RAMP REPORT REGION 2 ADA 2026

Route 7 – Vine Street
Belfast

CR09018

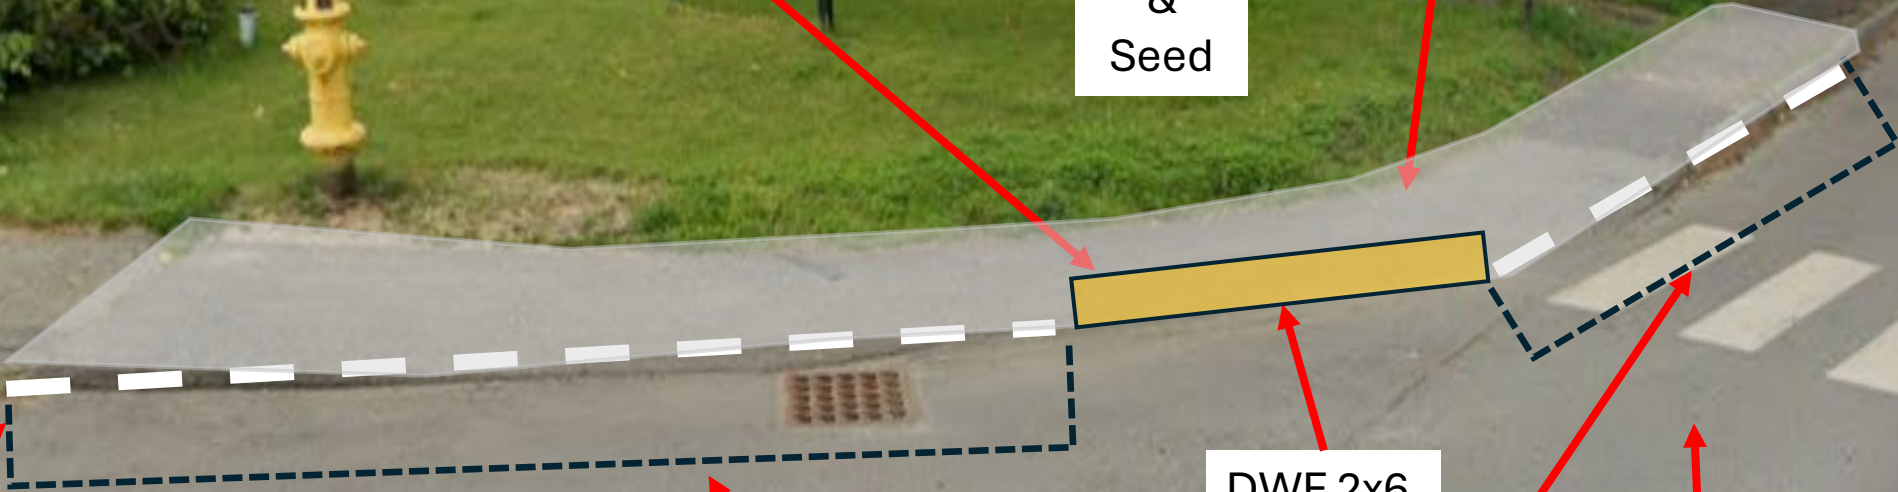
4'x4'
Turning
Area

Loam
&
Seed

Remove and regrade
sidewalk.

Remove 8' bituminous
curb then place new tip
down.

Saw cut 2' from face of
curb/gutterline. Base and
repave after curb install.

Remove 8' bituminous
curb then place new tip
down.

DWF 2x6

CR09019

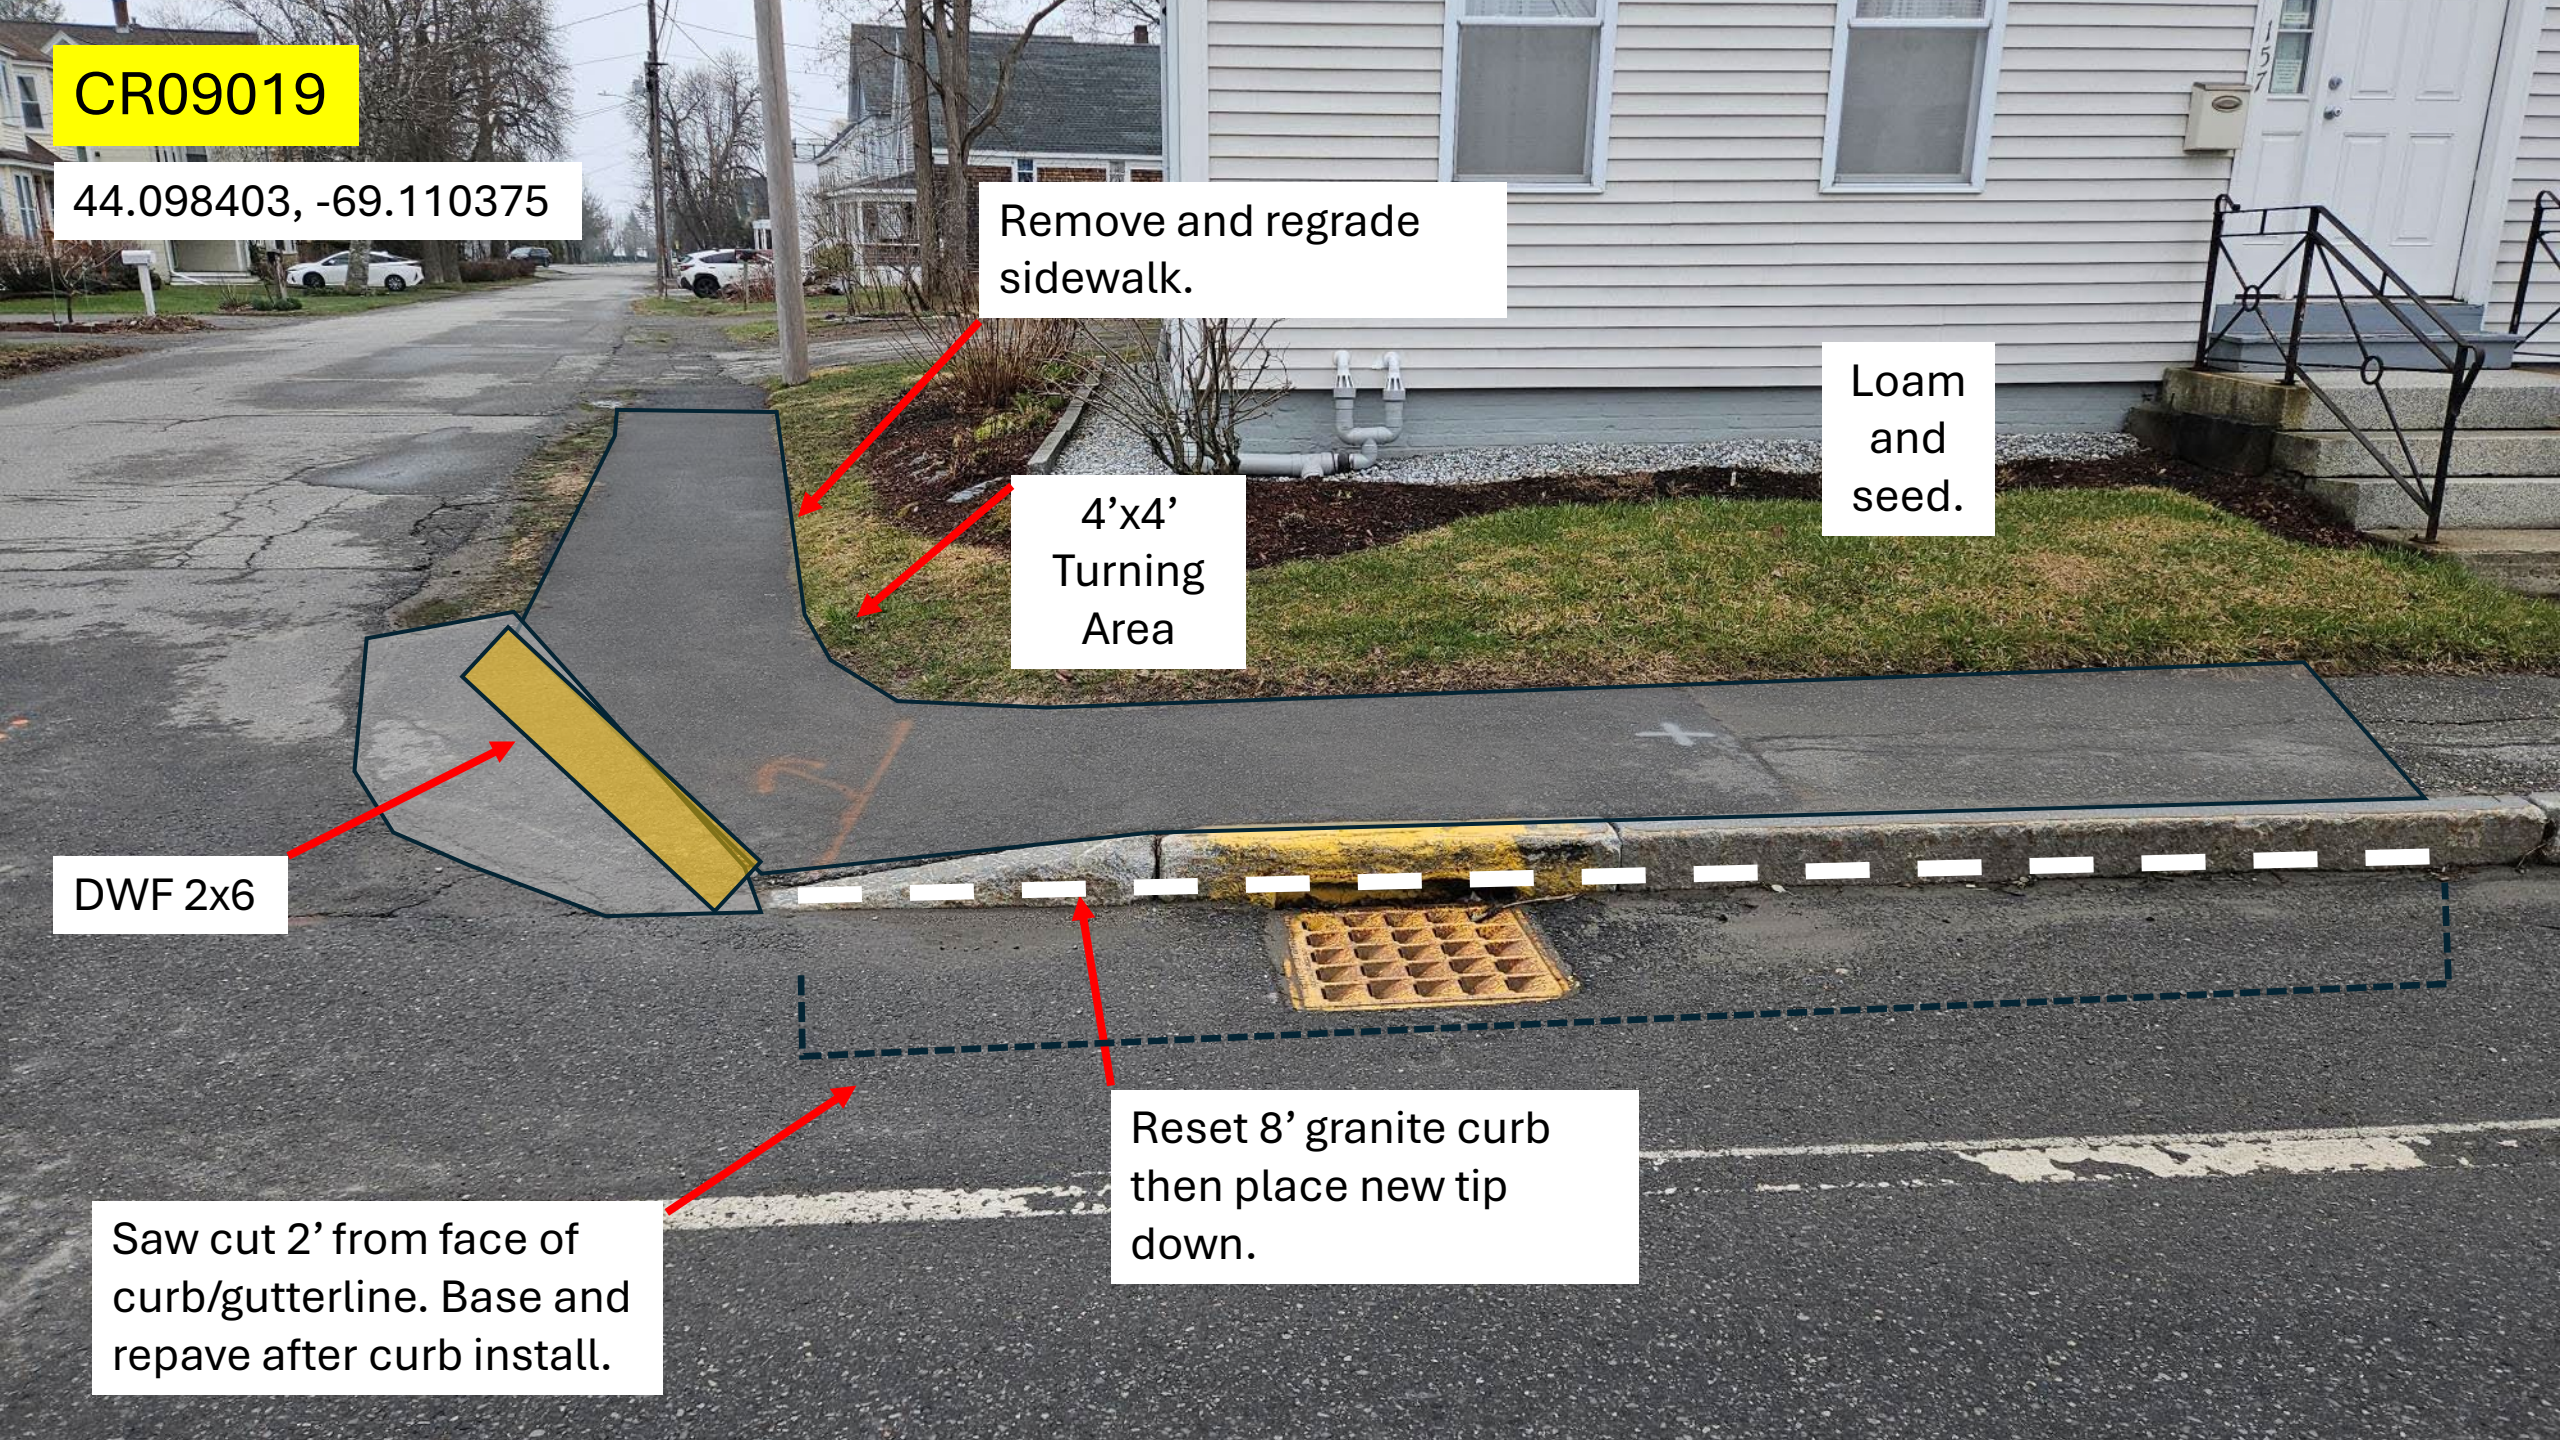
Remove and regrade sidewalk.

Loam and seed.

4'x4'
Turning
Area

DWF 2x6

Saw cut 2' from face of
curb/gutterline. Base and
repave after curb install.

Reset 8' granite curb
then place new tip
down.

CR09020

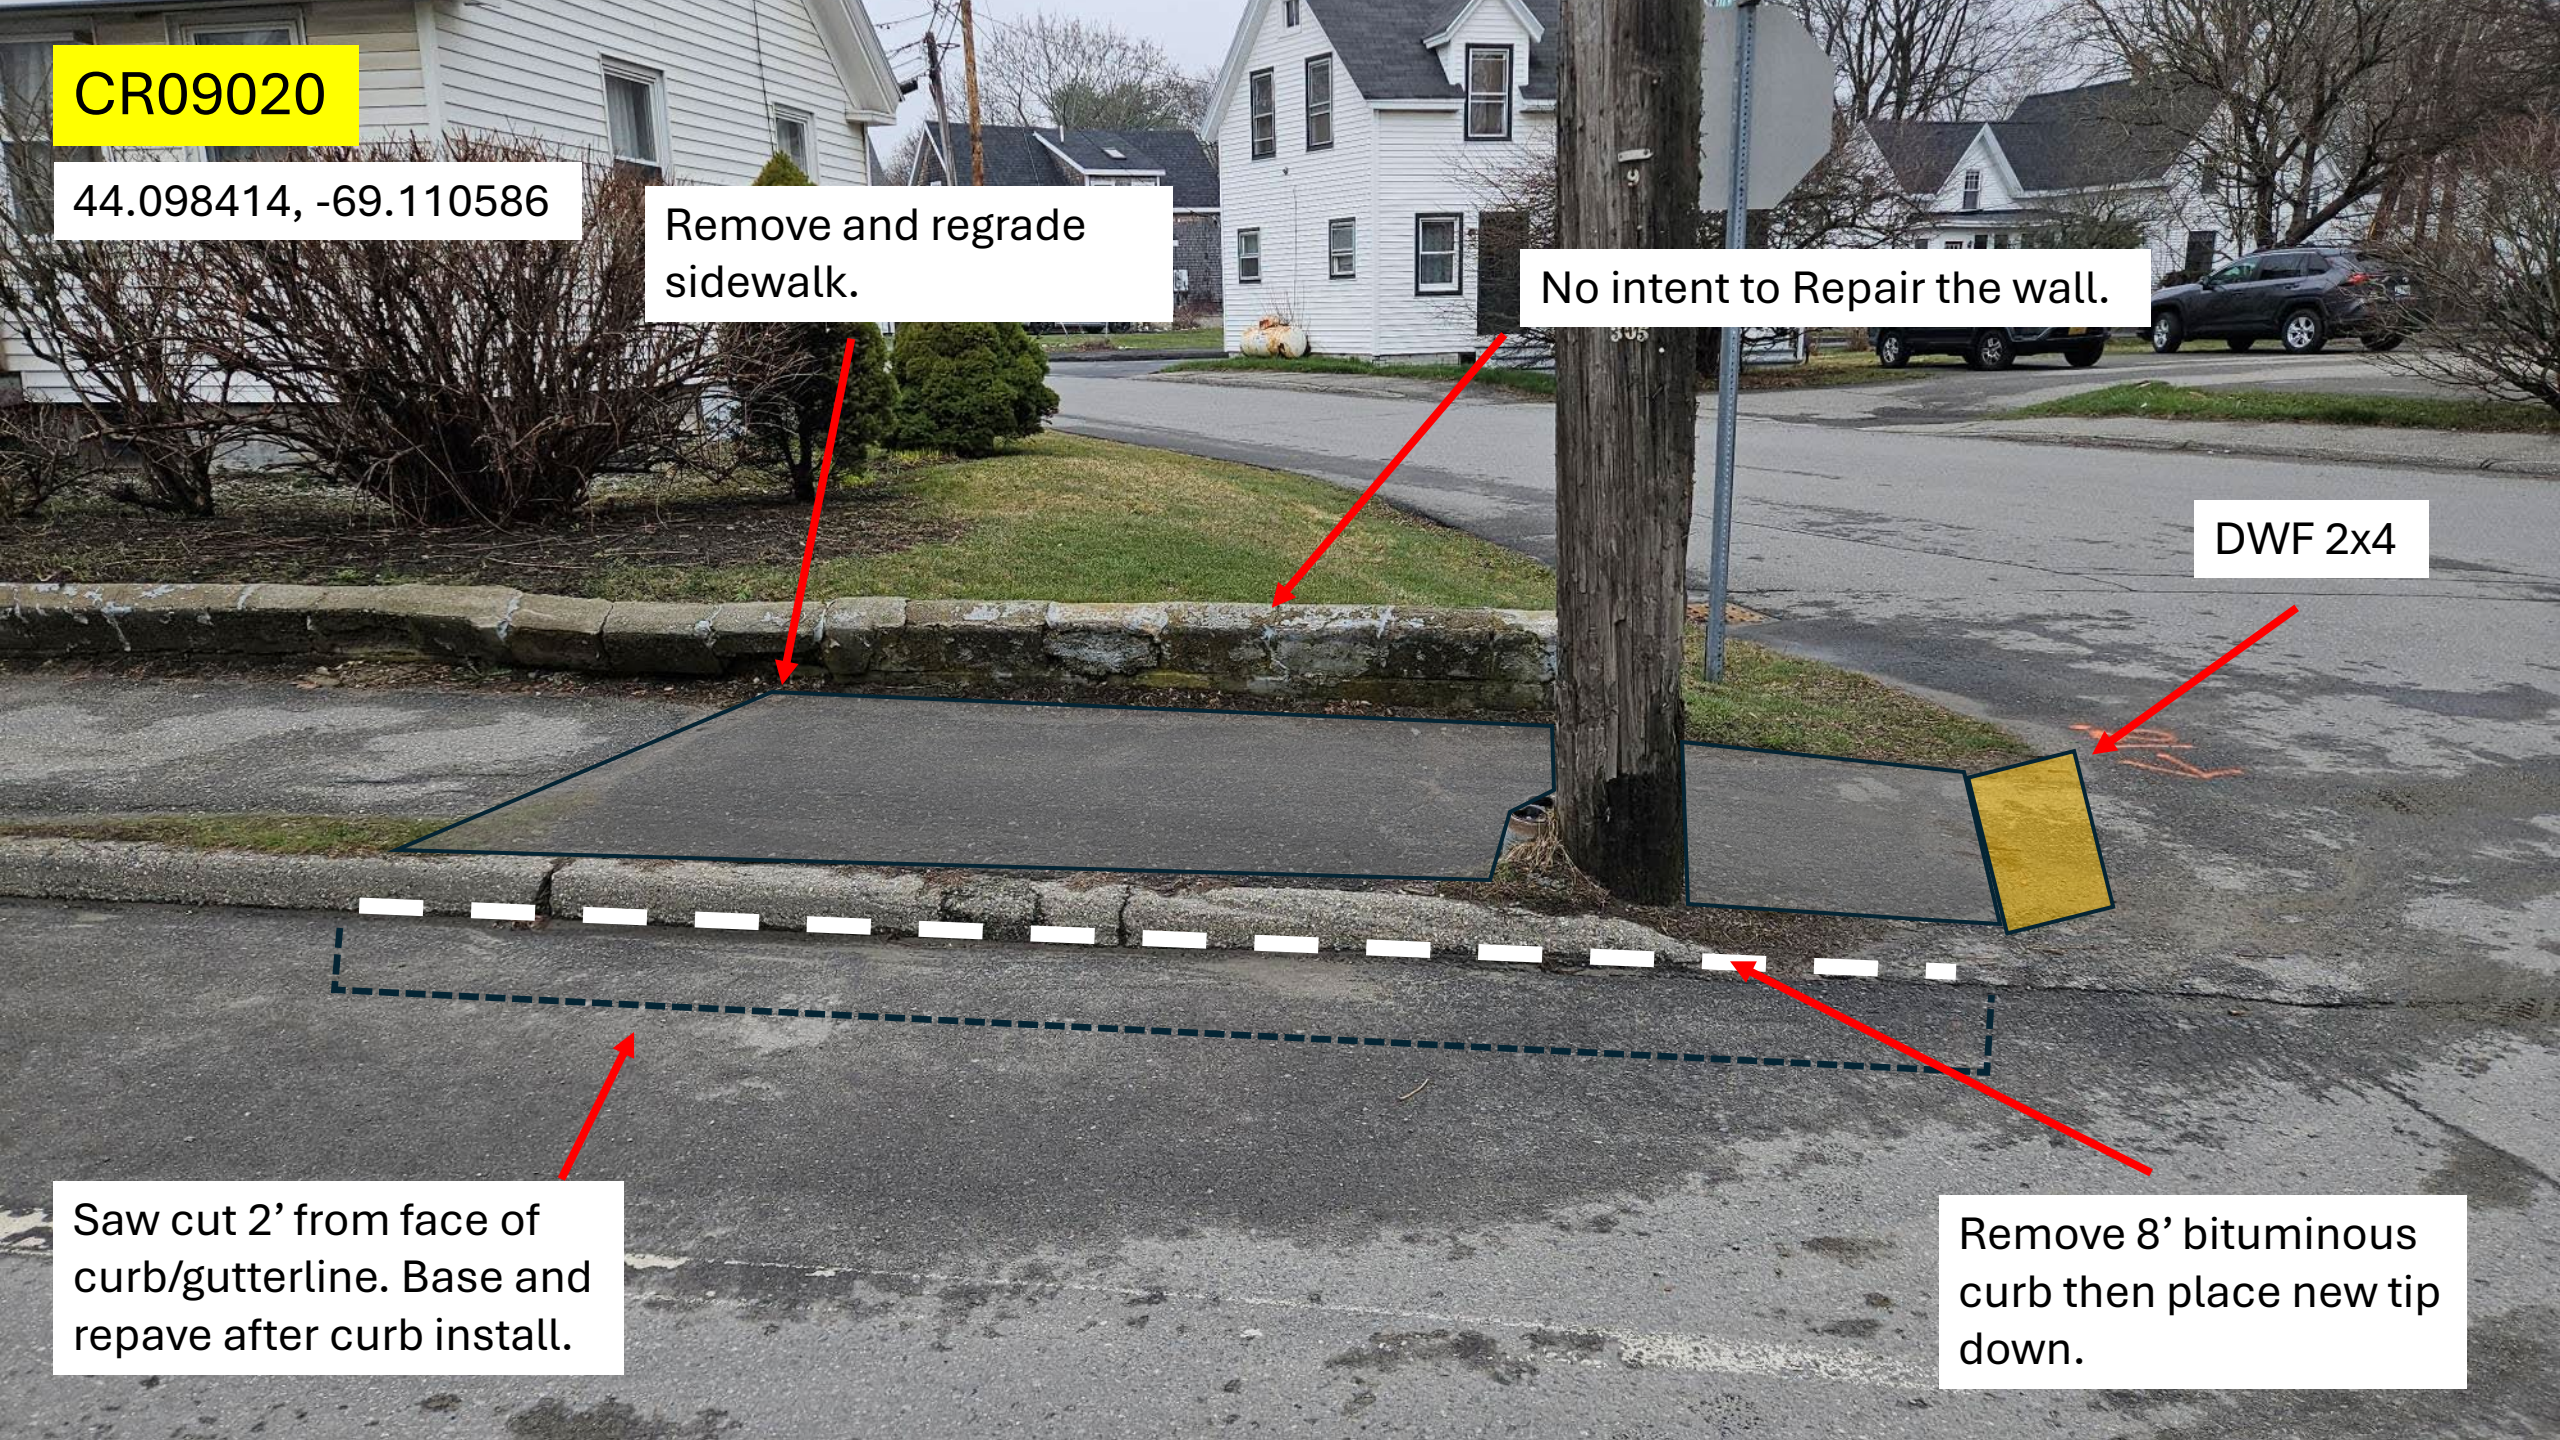
Remove and regrade sidewalk.

No intent to Repair the wall.

DWF 2x4

Saw cut 2' from face of curb/gutterline. Base and repave after curb install.

Remove 8' bituminous curb then place new tip down.
